Product Change Notification

Change Notification #: 113124 - 00
Change Title: 2U PCIE Riser Spare A2UL16RISER and A2UL8RISER
PCN 113124-00, Product Design
Update Resistors and Capacitors
Date of Publication: July 08, 2014

Figure 1 Component Locations for the 2U Riser Spare A2UL8RISER

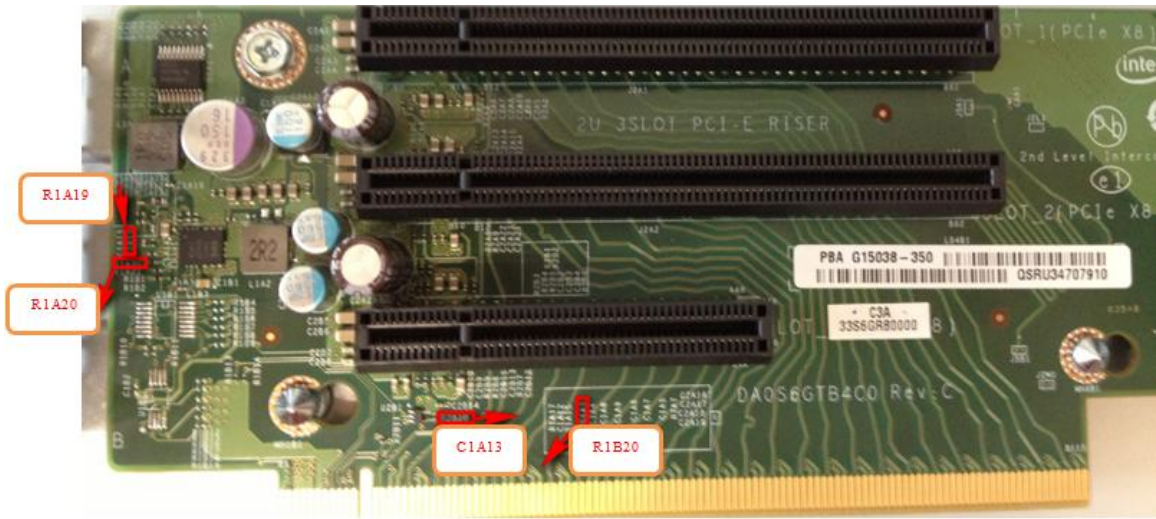
Intel is implementing the following changes on the 2U PCIE Riser Spare A2UL8RISER and A2UL16RISER to make an improvement of the 3.3 Voltage Regulator Startup Over current to support the current. Before this change, the Voltage Regulator on the riser card may not be able to turn on when the total current drawn is more than 4-5A current. After this change, the Voltage Regulator on the riser card can support more than 10A current.

Table 1 Component Updates for the 2U Riser Spare A2UL8RISER

Component	Location	Pre-change	Post-change
Resistor	R2B10	10.0 kOhm	3.65 kOhm
Resistor	R1A20	0 Ohm	30 Ohm
Resistor	R1A19	40.2 kOhm	20 kOhm
Capacitor	C1A13	10 pF	120 pF
